RHODE ISLAND
DEPARTMENT OF ENVIRONMENTAL MANAGEMENT

To: Licensed ISDS Designers, Approved Installers and Other Interested Parties
Date: April 30, 2004
Subject: Advisory Concerning BSF Design and Installation Procedures – Cold Weather Related Design Adjustments and Precautions

Selected paragraphs of the BSF Guidance Document are revised as follows:

FIGURE 8A — ORIFICE SHIELD & LATERAL DETAILS

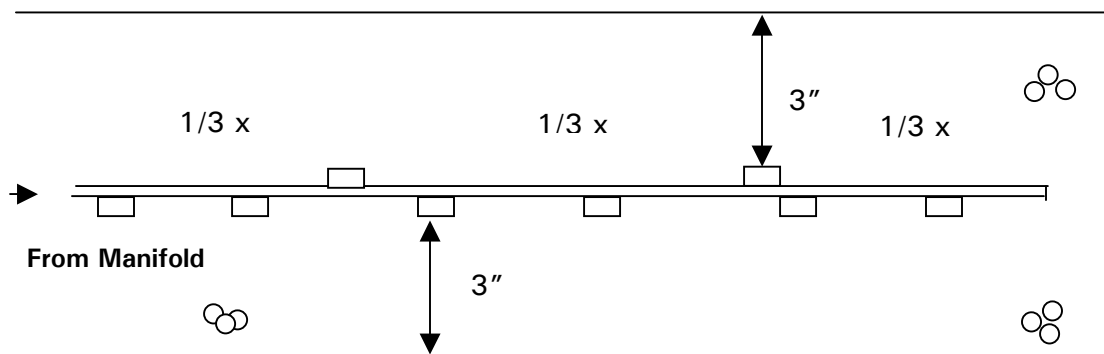
A series of 1/8 inch diameter holes (orifices) shall be drilled in the distribution laterals and spaced no less than 14 inches and no more than 24 inches apart. **Two (2) orifices in each lateral shall be drilled pointing up (12 o'clock position); all other orifices shall be drilled pointing down (6 o'clock position). The up-pointing orifices shall be located approximately 1/3 and 2/3, respectively, along the length of each lateral. Orifice shields shall be placed over each orifice (above or below the lateral, as required).** Orifice shields placed below any orifice shall contain slots or holes to provide free draining (usually referred to as cold weather orifice shields). See Figure 8.

(f) After the required amount of filter sand has been added to the filter, place (3) inches of 3/8" washed pea stone over the filter sand. After the distribution laterals and orifice shields have been assembled atop the pea stone, **add more pea stone so that a three (3) inch depth of pea stone is installed over the laterals and any upper orifice shield (See Figure 8A). The total depth of pea stone over the sand media will range from eight (8) to nine (9) inches, depending on the size of lateral pipe employed.** No filter fabric of any kind should be placed between the sand and overlying pea stone.
